Product change notification

Declaration of improved InLine II product range

Dimensional changes for 1 pole variants of sizes ZLBM123-2SC

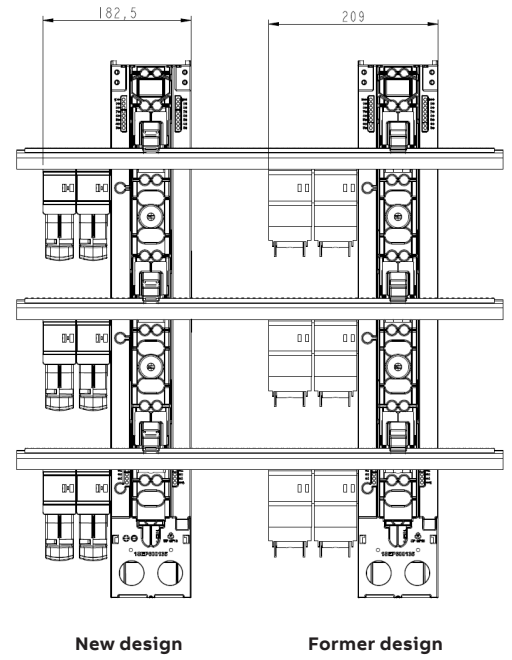
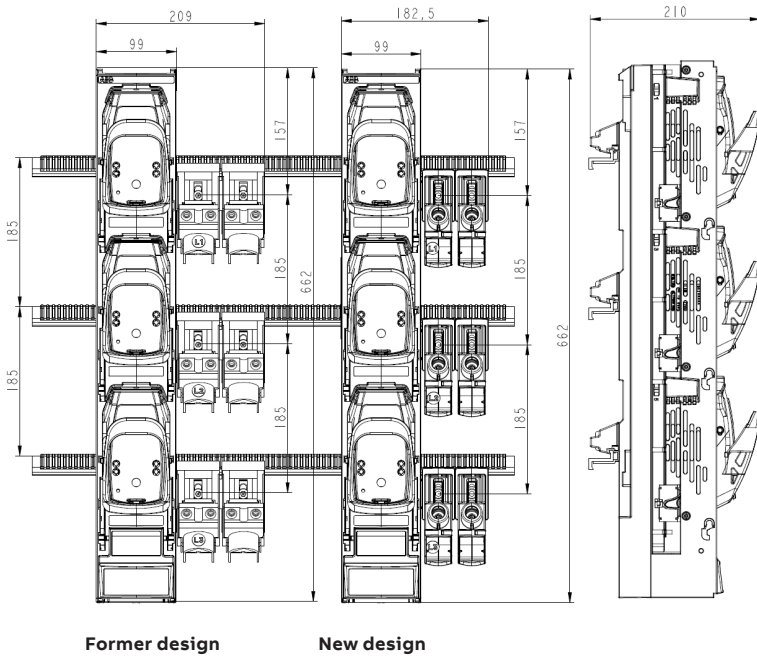
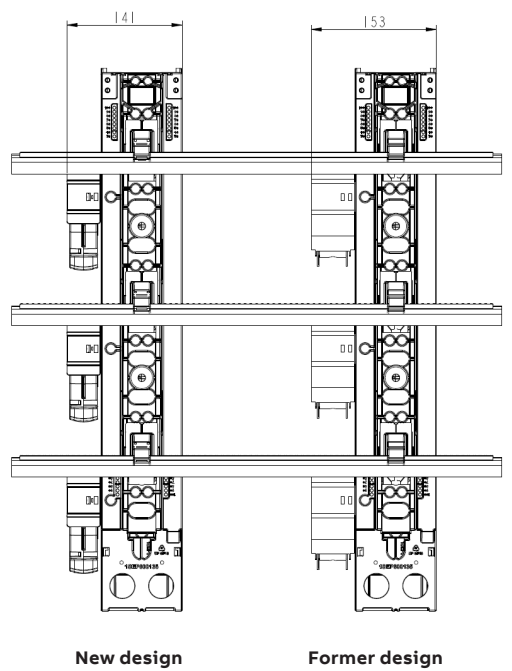
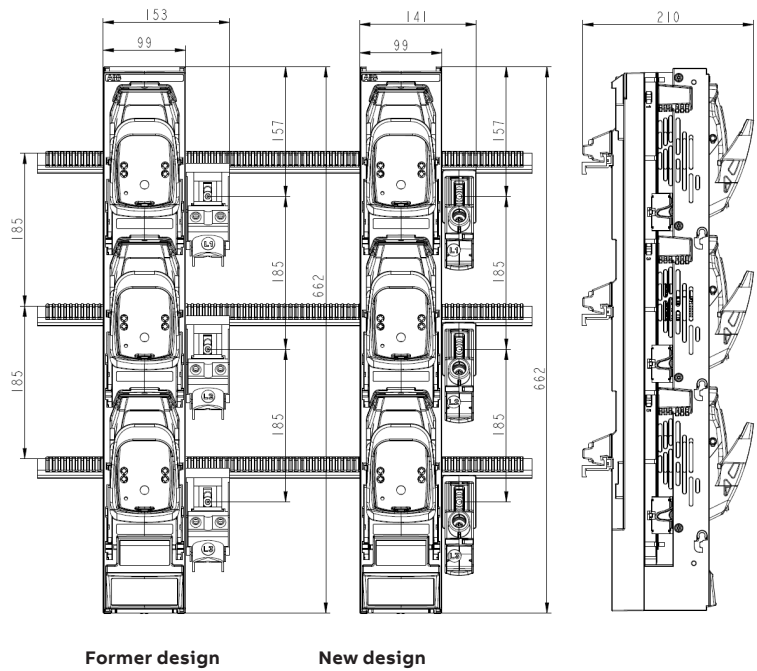
Two side connector

One side connector

Dimensional changes for 3 pole variants of sizes ZLBM123-2SC

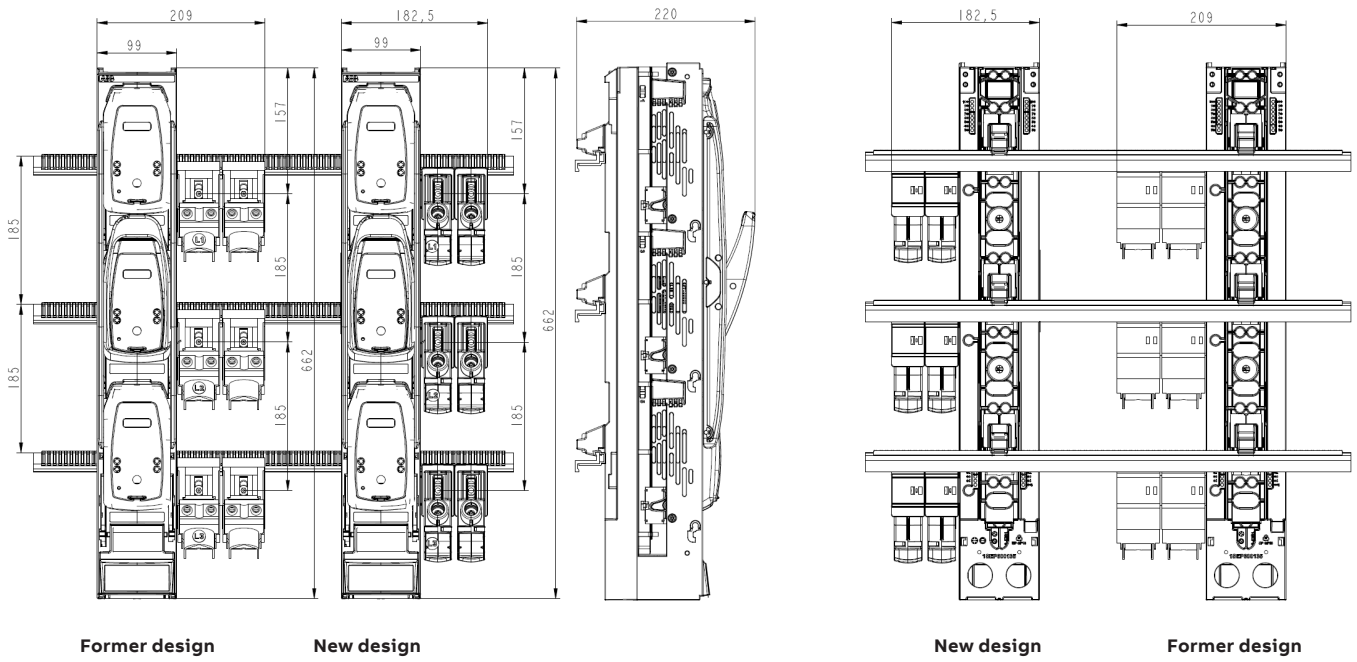
Two side connector

One side connector
